Update to Method 2017, Internal visual (hybrid)

Identification of anomalies for MIL-STD-883 TM2017 (internal Visual)

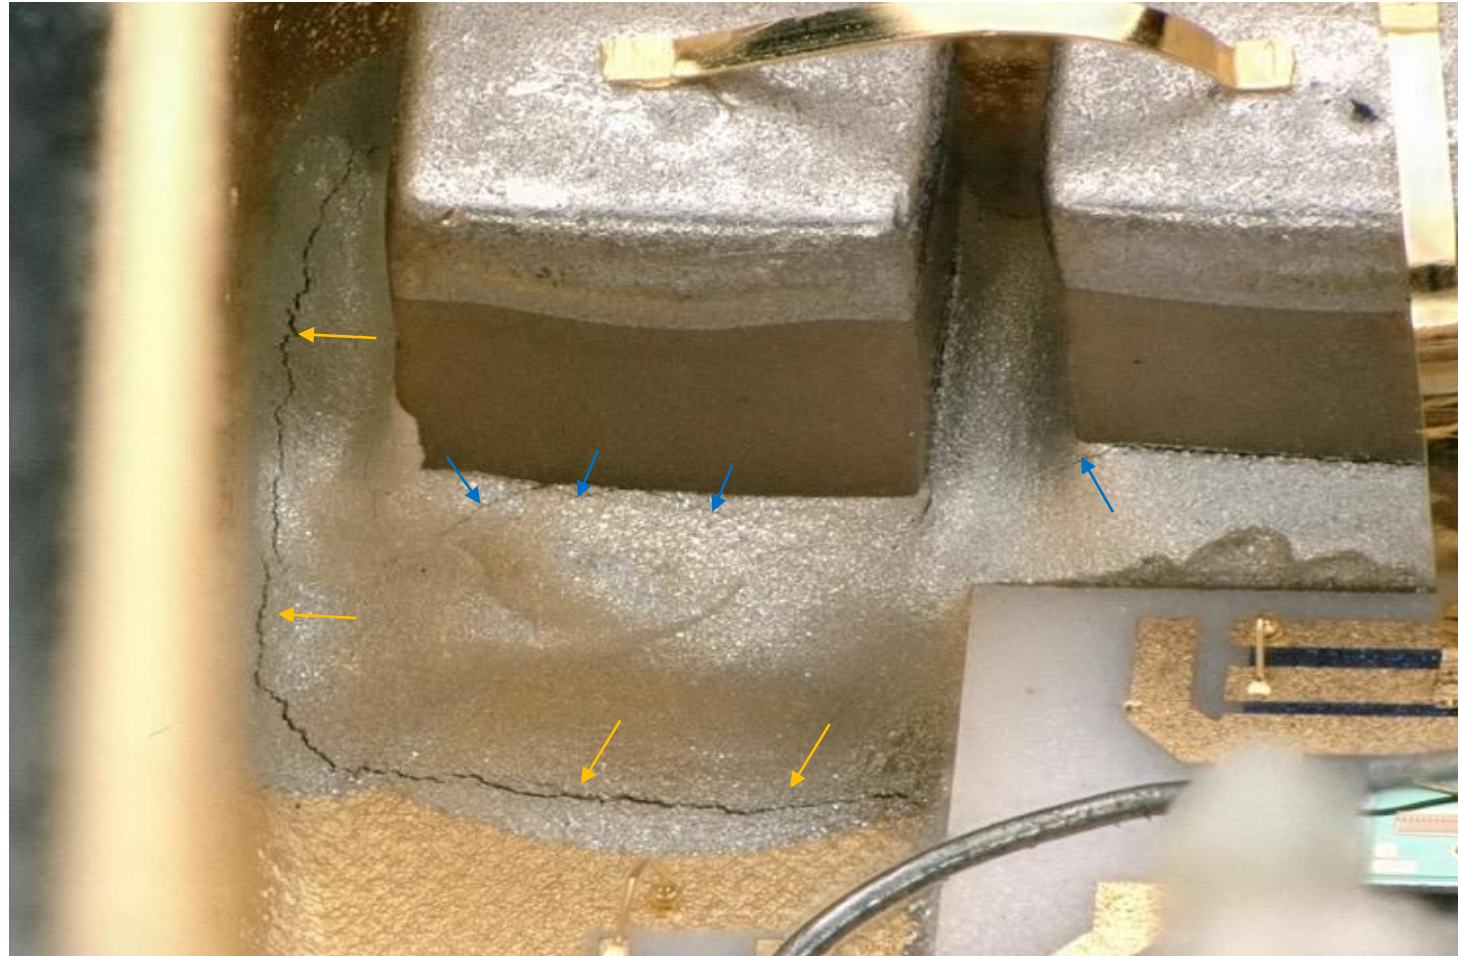
These defects look to be pull-back which are technically not a cause for rejection, but the excessive length (total width of the epoxy) makes this very concerning.

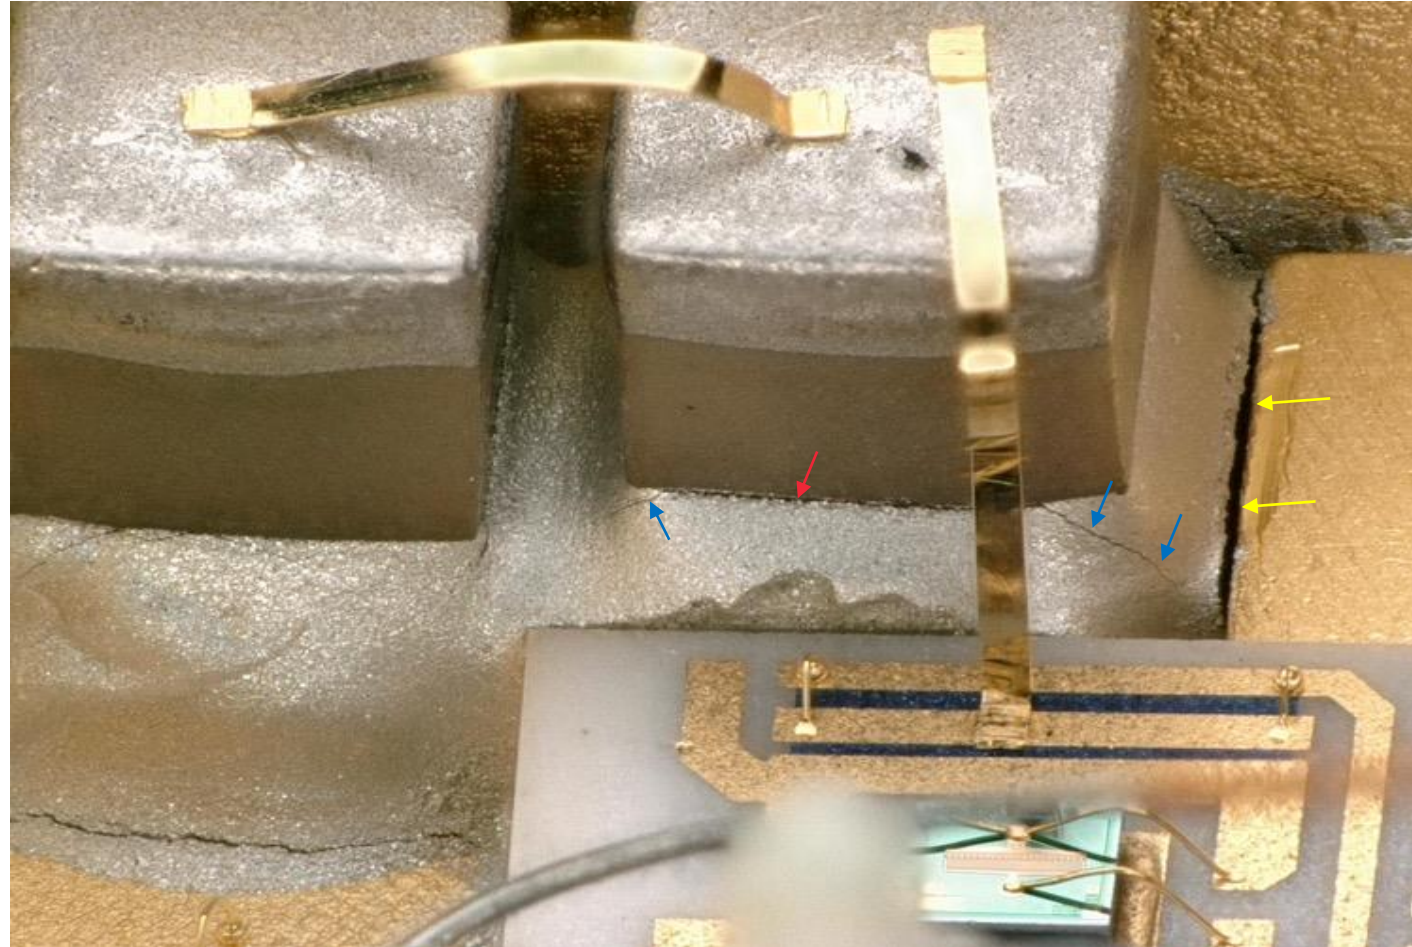
Orange arrows are Cracks. There is epoxy on both sides of the crack, meaning that it is not pulling back from another material (e.g. substrate or element). Each individual crack changes in width, meaning that it meets the TM2017 definition of a crack. **Blue** arrows are fissures and not considered rejectable.
